Meliadine Extension

Response to Technical Comments

Submitted to:
Nunavut Impact Review Board

Submitted by:
Agnico Eagle Mines Limited – Meliadine Division

Figure 10.3-2: Receptors Locations for the Human Health Risk Assessment – Meliadine Extension

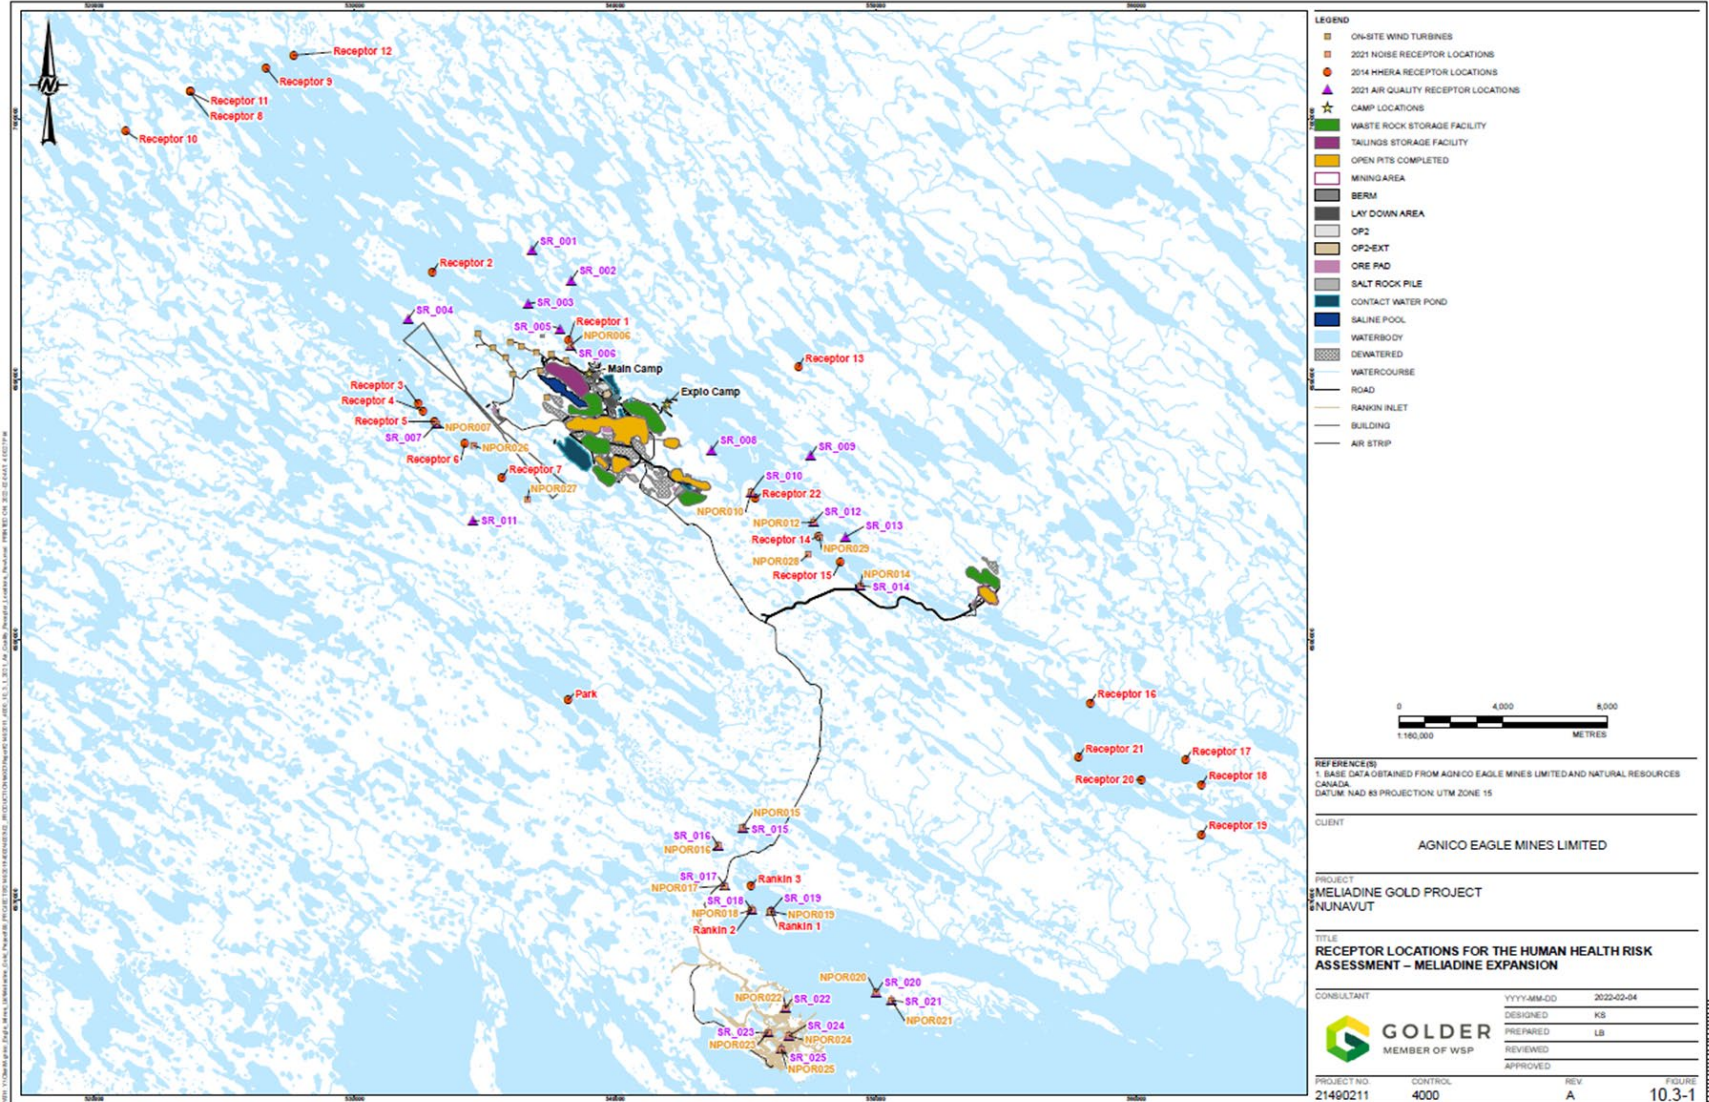
1. Clarify which receptor locations were included in the current assessment and for which environmental media/pathways.
2. Revise Figure 10.3-2 to clearly identify the Extension activities relative to the receptor locations.

As discussed in Section 10.3.7.2 (Project Environment) and Section 10.3.7.4 (Air Quality), all receptor locations as presented in Figure 10.3-2 were included in the HHRA. For the Meliadine Extension FEIS Addendum, the receptor locations from the 2014 FEIS were carried forward for the assessment of TSP, PM₁₀, PM_{2.5}, dust, metals, PAHs, and VOCs in air, and new air predictions from 2021 for NO₂ and SO₂ was added. Figure 10.3-2 also present the noise points of reception (NPOR) were updated noise predictions were provided for the HHRA.
